UNITED STATES PATENT AND TRADEMARK OFFICE

APPLICATION NO.	FILING DATE	FIRST NAMED INVENTOR	ATTORNEY DOCKET NO.	CONFIRMATION NO.
10/065,879	11/27/2002	Christopher A. Newton	BUR920010144	5280
30449 7590 03/16/2007 SCHMEISER, OLSEN & WATTS 22 CENTURY HILL DRIVE SUITE 302 LATHAM, NY 12110			EXAMINER LUND, JEFFRIE ROBERT	
			ART UNIT 1763	PAPER NUMBER
SHORTENED STATUTORY PERIOD OF RESPONSE			MAIL DATE	DELIVERY MODE
3 MONTHS			03/16/2007	PAPER

Office Action Summary

DETAILED ACTION

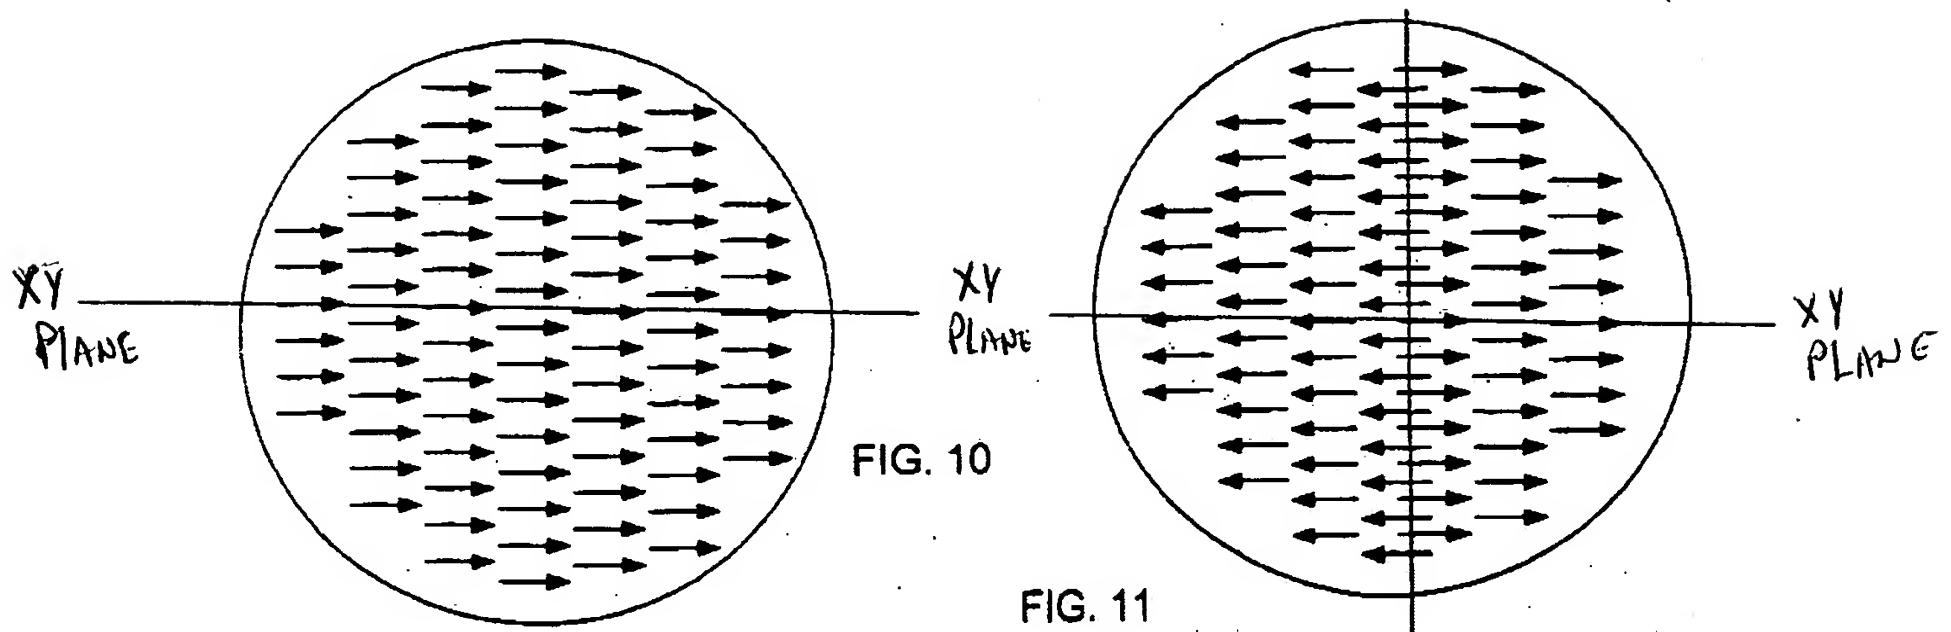
Appellants' respectfully submit that the angle of 45 to less than 90 degrees (i.e. 72°) with respect to the XY plane of the distribution plate of Deacon et al. could not be the offset angles α_1 and β_1 , and α_2 and β_2 , of claims 3 and 19 because FIG. 19 of Deacon et al. only teaches two dimensions. FIG. 19 of Deacon et al. only teaches the bottom surface of the distribution plate which is perpendicular to the XY plane of Deacon's distribution plate. Nowhere does Deacon et al. teach or suggest offset angles with respect to the XY plane.

Deacon et al. describes that FIG. 19 "shows a hole pattern with alternating directions of holes adjacent one another." Deacon et al., column 8, lines 54 - 56. Nowhere in FIG. 19 or its description does Deacon teach or suggest any plane other than the surface of the distribution plate. Further, the only directions Deacon discloses are "alternating directions of holes adjacent one another" in the surface of the distribution plate. Id. Deacon does not disclose the orientation of FIG. 19 with respect to the wafer or substrate. Appellants respectfully contend that Deacon et al. is incapable of teaching or suggesting the offset angles of claims 3 and 19, because Deacon et al. only teaches or suggest one plane or two dimensions in all its Figures and disclosure.

Appellants respectfully submit that contend that the Examiner has not presented an argument directed to the preceding requirements of claims 3 and 19. The Examiner maintains that Deacon et al. teaches Appellants offset angles α_1 and β_1 and α_2 and β_2 of Claims 3 and 19. Yet FIG. 19 of Deacon et al. only teaches two dimensions.

The Examiner disagrees. The Applicant has misunderstood the drawings of Deacon et al. Figure 6 of deacon shows the XY plane. Figures 10-24 show the XZ plane. When taken together they present a three dimensional view of the showerhead. The α_1 and β_1 and α_2 and β_2 offset angle is represented by the angle between the arrows. For example, looking at figure 10 all the arrows lie in an XY plane and face the same direction so there is not α_1 and β_1 and α_2 and β_2 offset. In figure 11, all the arrows lie in

the XY plane but half the arrows are offset 180 degrees.

FIG. 21

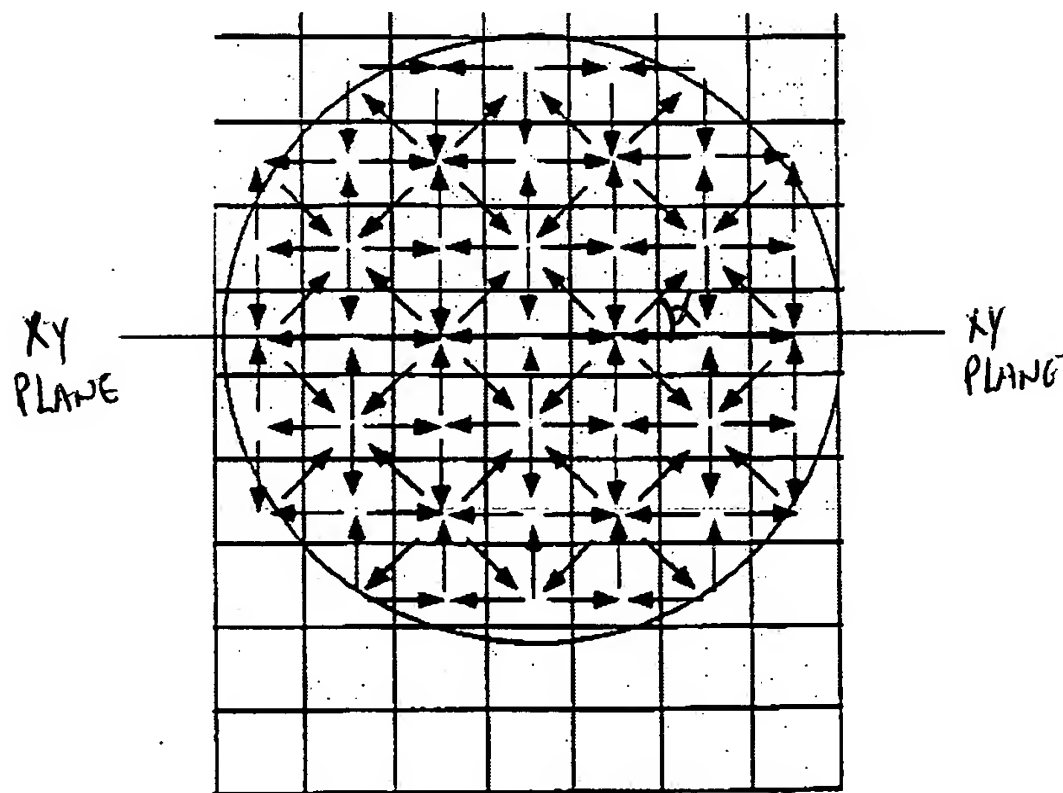
Figures 12 through 24 clearly show a wide variety of off set angle. Figure 21 clearly shows an offset of $\pm 45^\circ$.

Thus, Deacon et al clearly teaches a three dimensional showerhead with α_1 and β_1 and α_2 and β_2 offset of $\pm 45^\circ$.
